CONTRACT CHANGE ORDER NO. 240
SHEET 2 OF 14

MARK	DATE	DESCRIPTIONS	BY	CH'D	CCO#
2	04/05/12	SUSPENSION SYSTEM SHIMS	GB	MN	240
1	04/16/07	CABLE SYSTEM	GB	DT	37

SAN FRANCISCO OAKLAND BAY BRIDGE
EAST SPAN SEISMIC SAFETY PROJECT
SELF-ANCHORED SUSPENSION BRIDGE
(SUPERSTRUCTURE & TOWER)

SUSPENDER BRACKET DETAILS NO. 2

TOWER SADDLE DETAILS NO. 4

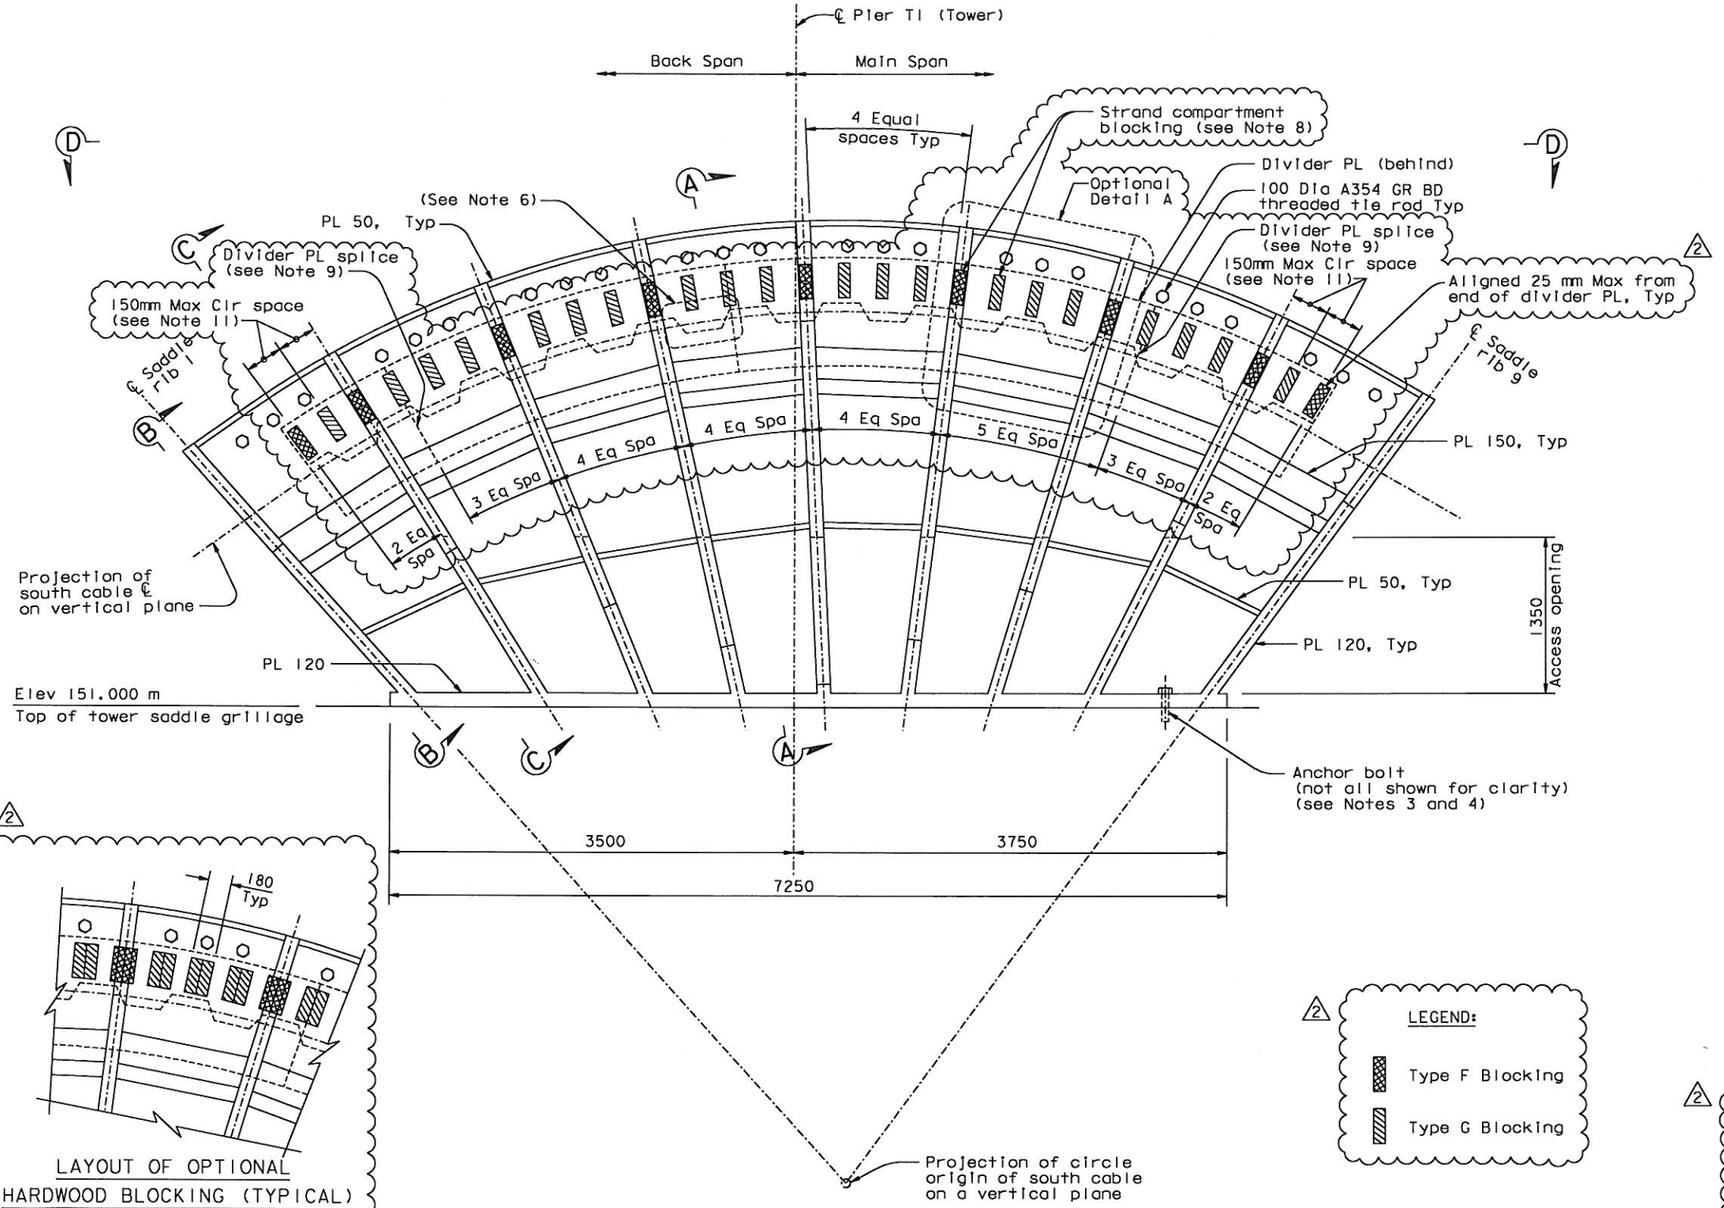
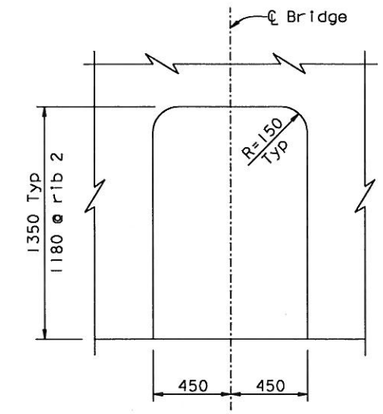
MARK	DATE	DESCRIPTIONS	BY	CH'D	CCO#
2	05/09/12	SADDLE BLOCKING	GB	MN	240
1	10/31/08	TOWER HEAD DETAILS	MN	GB	93

8. Contractor shall fabricate and install new blocking. For layout, see "Tower Saddle Details No.5B" sheet. For blocking details, see "Tower Saddle Details No.6" sheet.

9. The blocking shall be placed such that it straddles the divider plate spacing joint.
10. At the Contractor's option, hardwood blocking may be installed and left in place through load transfer. Hardwood blocking shall be installed in widths of 180 mm, and cut on site to fit tightly at each blocking location. After load transfer, hardwood blocking shall be left in place or replaced as directed by the Engineer.

11. Where clear distance adjacent to G blocking exceeds 150 mm, the Contractor shall install additional 90 mm wide Type G blocking in the space.

TOWER SADDLE DETAILS NO.5B

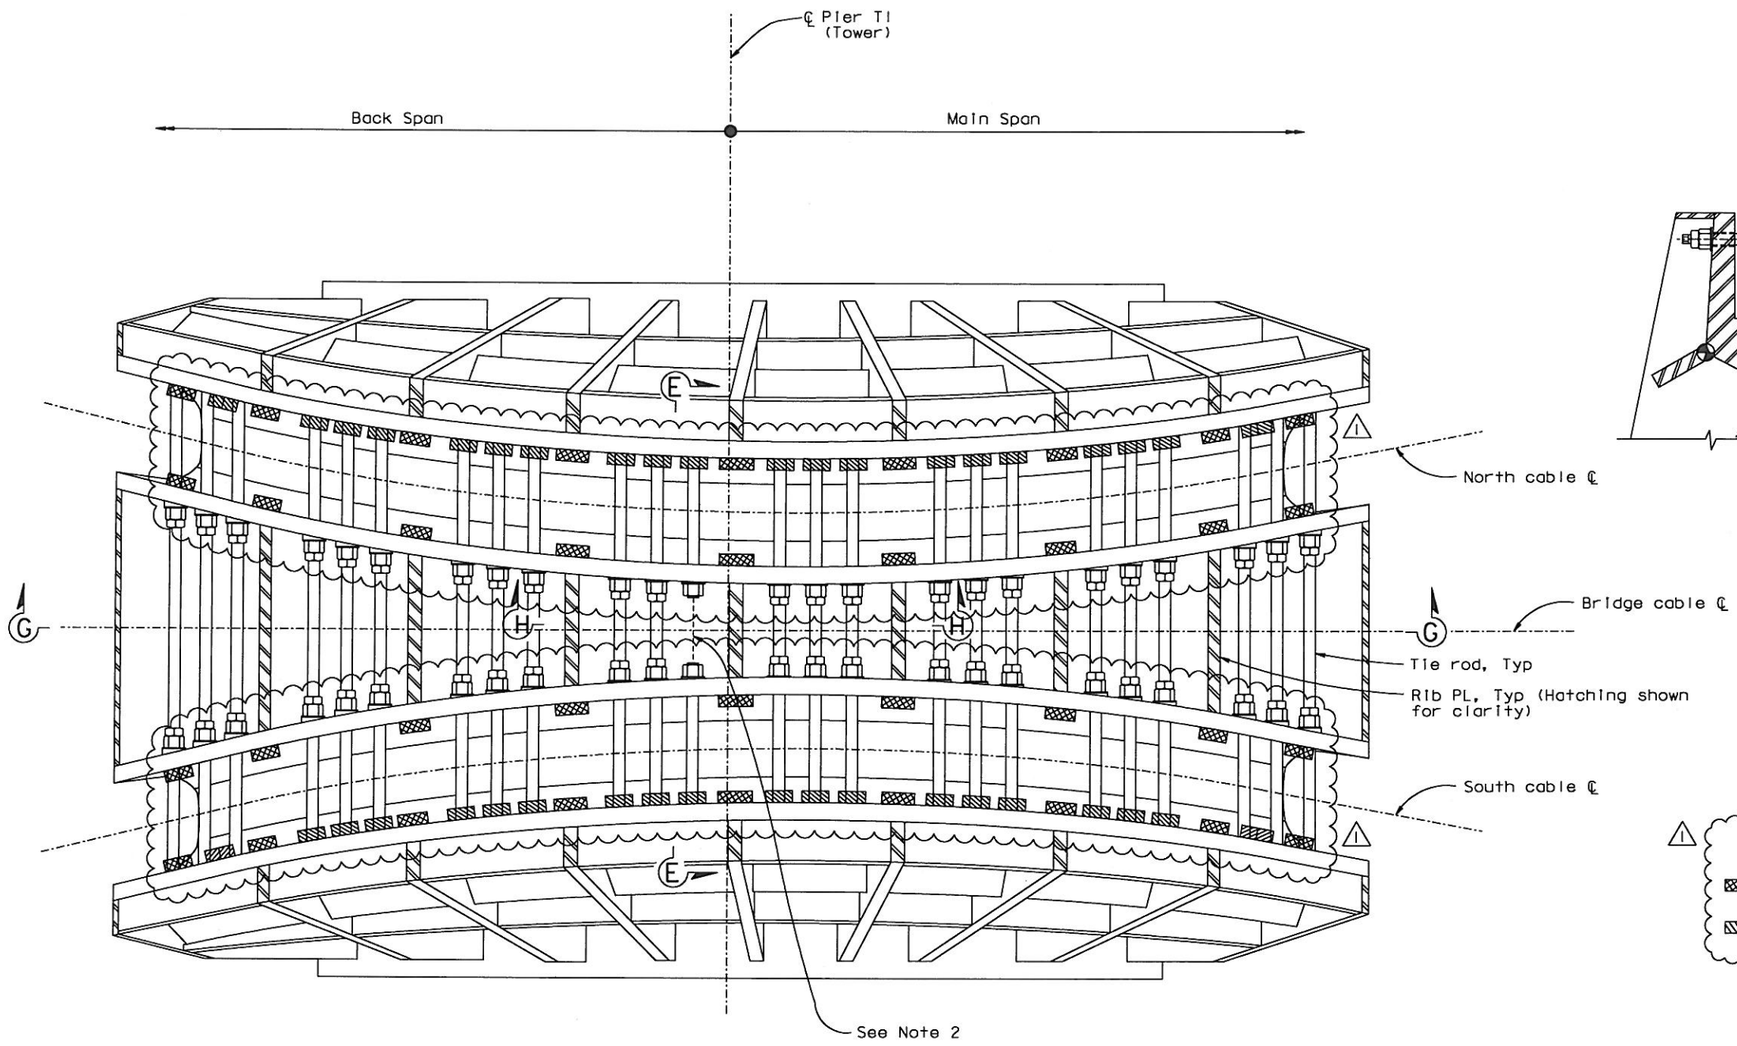
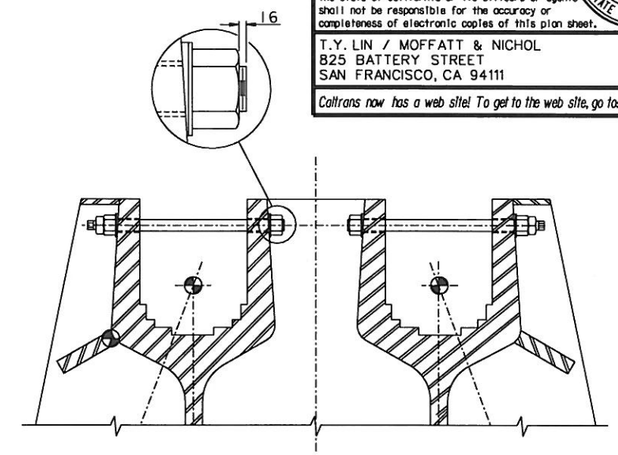
MARK	DATE	DESCRIPTIONS	BY	CH'D	CCO#
1	05/07/12	SADDLE BLOCKING	GB	MN	240
0	10/31/08	TOWER HEAD DETAILS	NV	MN	93

1. For Section G-G, see "Tower Access Details No.23" sheet. For Section H-H, see "Tower Saddle Details No.5A" sheet.
2. Tie rod is discontinuous between saddle troughs at this location only.
3. For blocking, see "Tower Saddle Details No.6" sheet.

DETAIL D
1:2

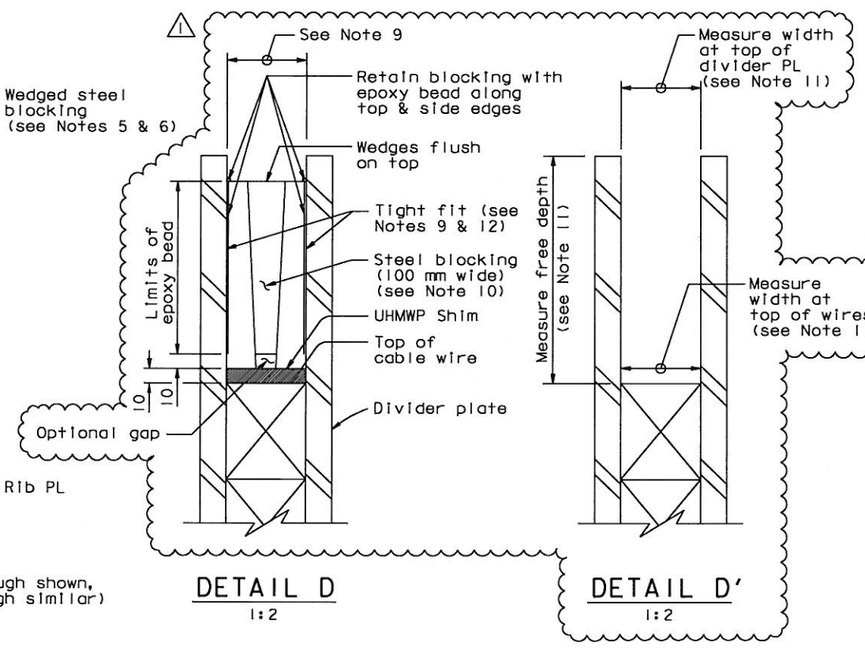
MARK	DATE	DESCRIPTIONS	BY	CH'D	CCO#
1	05/07/12	SADDLE BLOCKING	GB	MN	240

8. The tapered faces of the divider plates shall be placed facing the centerline of the bridge.
9. Prior to fabrication of new blocking, the Contractor shall measure as-built compartment widths. The blocking shall be fabricated to fit tightly at top and bottom within the as-built compartment dimensions.

10. At the Contractor's option, the steel blocking may be fabricated in several pieces. The taper of any piece shall not exceed 1:20. Provide adhesive between surfaces of blocking pieces.

11. Tower Saddle survey (see Detail D'):
    - Measure compartment width at top & bottom
    - Measure compartment depth
    - Measure at each blocking sections Type F & G

- At each section, measure all 13 compartments
12. The completed blocking at each location is fabricated to fit tightly. Should tight fit not be achieved, the Contractor shall inform the Engineer for evaluation.

ELEVATION OF TYPICAL EAST SADDLE (IN THE PLANE OF CABLE) (See Note 6)

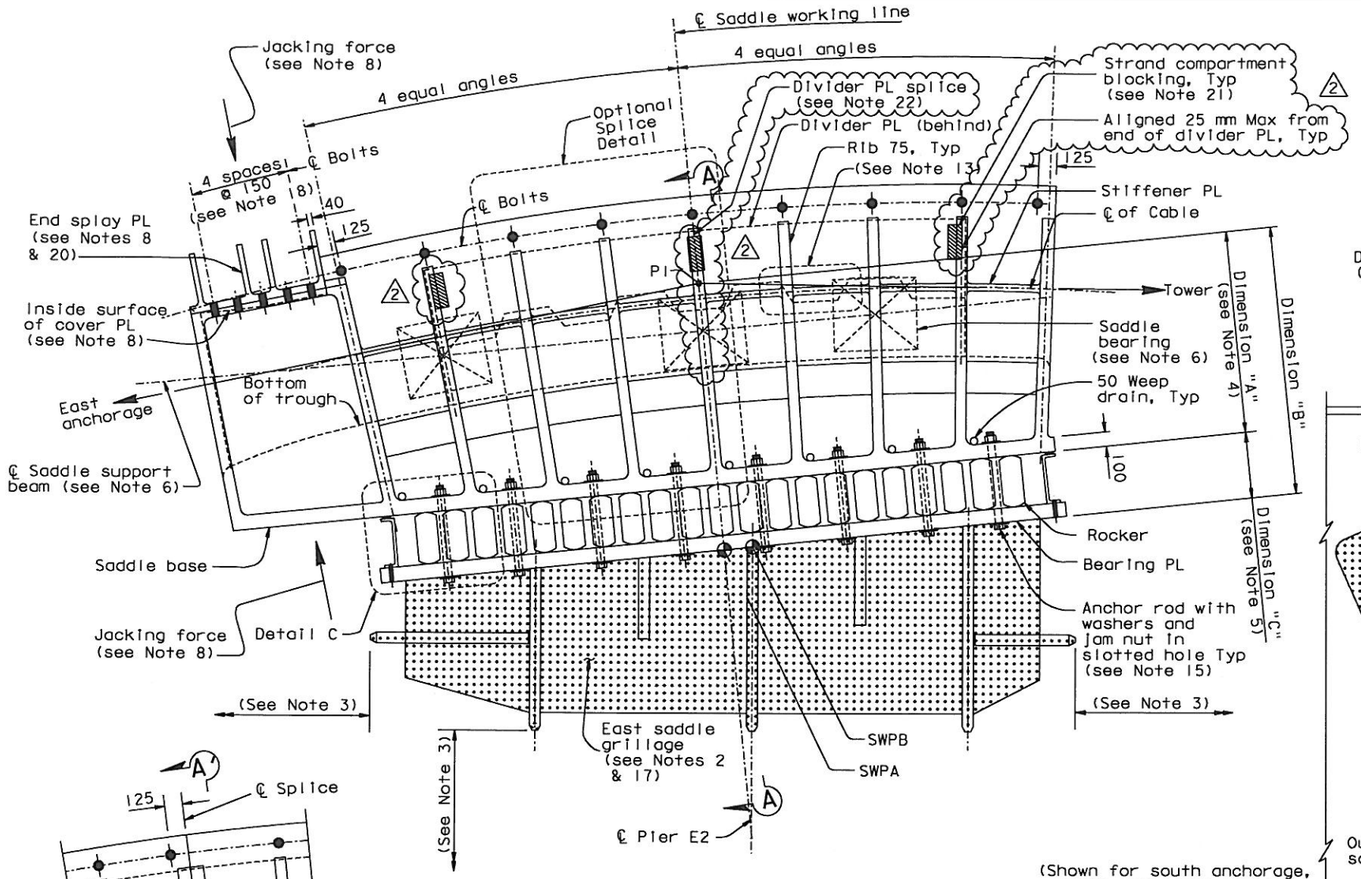
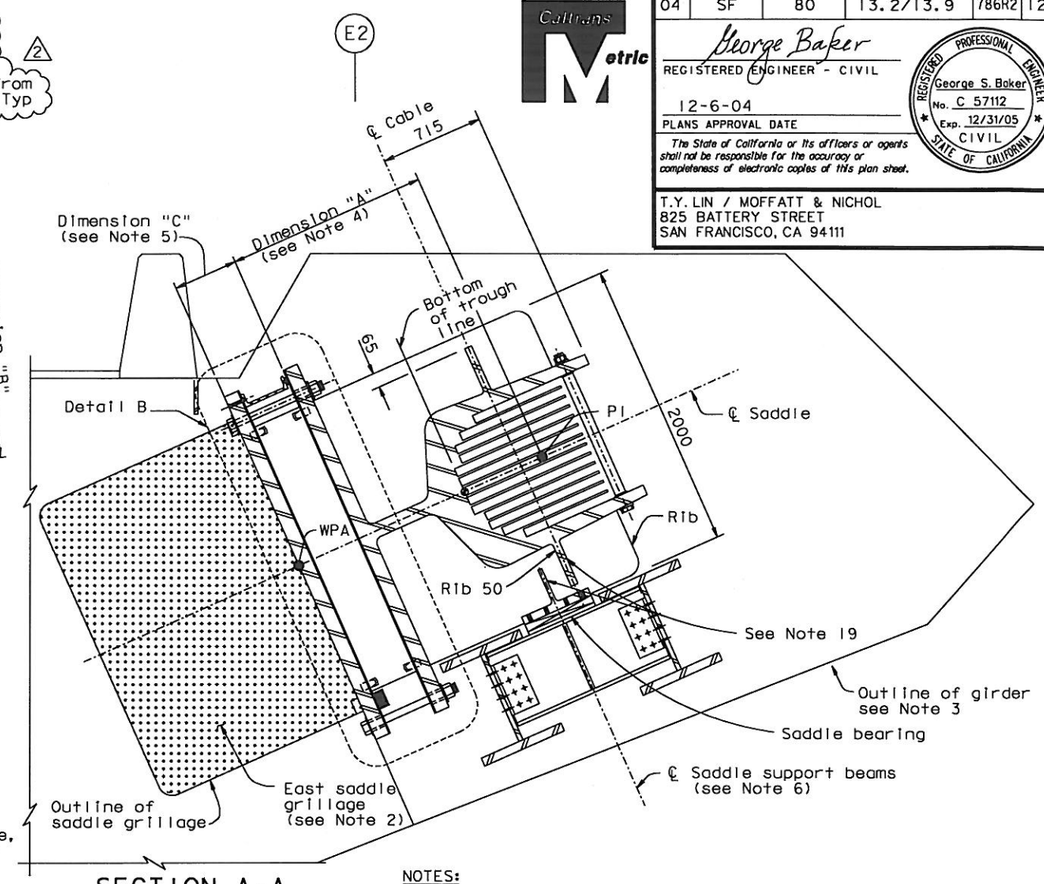
2 21. The Contractor shall fabricate and install new blocking. For typical blocking, see Section A-A on "East Saddle Details No.5" sheet. For typical blocking details, see "East Saddle Details No.5A" sheet.

SECTION A-A - TYPICAL
1:10

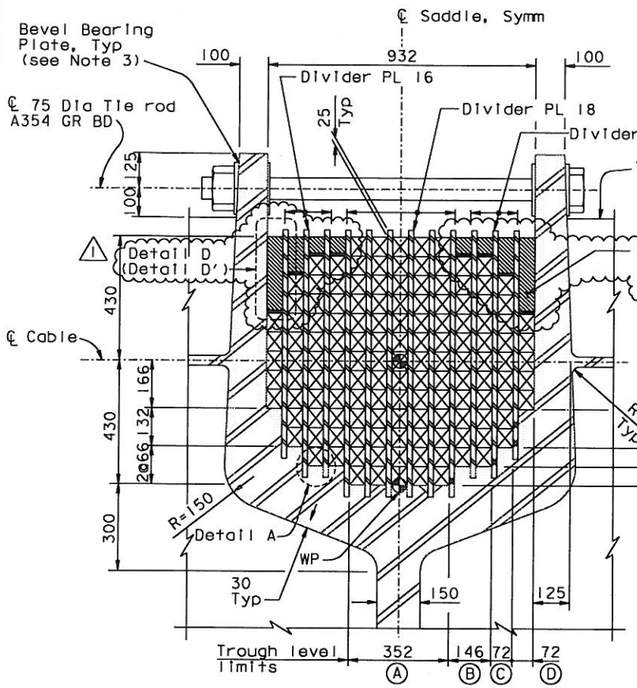
5. For steel blocking layout, see "East Saddle Details No.3" sheet. For Detail D, see "East Saddle Details No.5A" sheet.

LAYOUT OF OPTIONAL HARDWOOD BLOCKING (See Note 7)

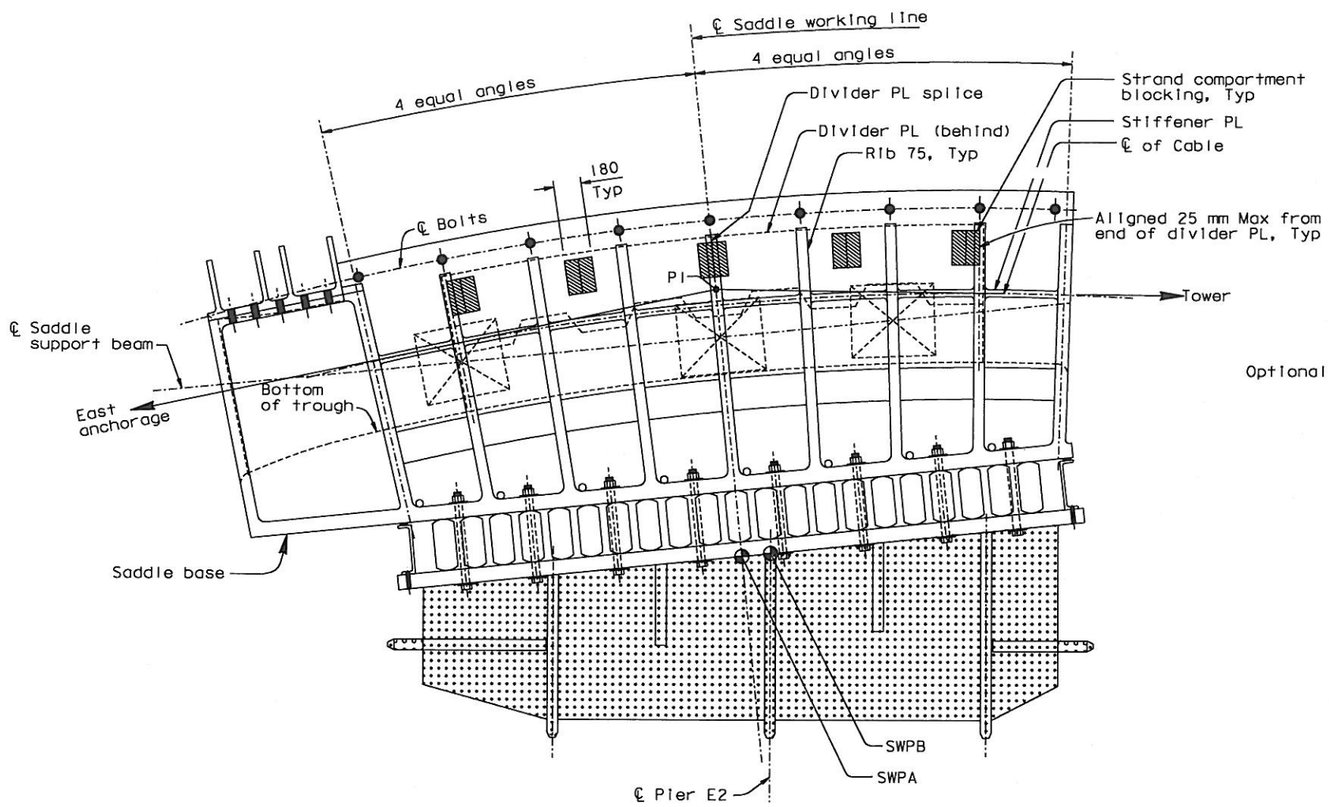
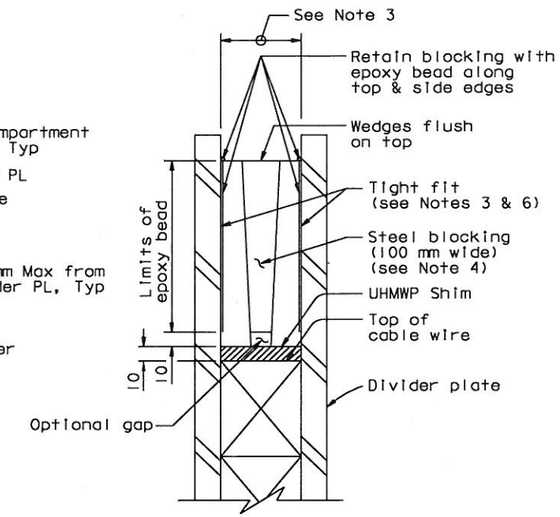
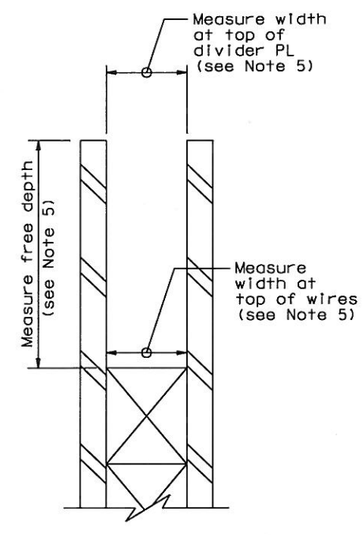
1. Wedged steel blocking layout is shown on "East Saddle Details No. 3" sheet.
2. Steel shall be ASTM A572. Surfaces of wedged steel plates against the divider plates shall have PTFE film (0.5 mm thick). All surfaces of steel shall be primed.

4. At the Contractor's option, the steel blocking may be fabricated in several pieces. The taper of any face shall not exceed 1:20. Provide adhesive between surfaces of blocking pieces.

5. East saddle survey (See Detail D')
   - Measure compartment width @ top and bottom
   - Measure compartment depth
   - Measure @ each blocking section
   - At each section measure all compartments
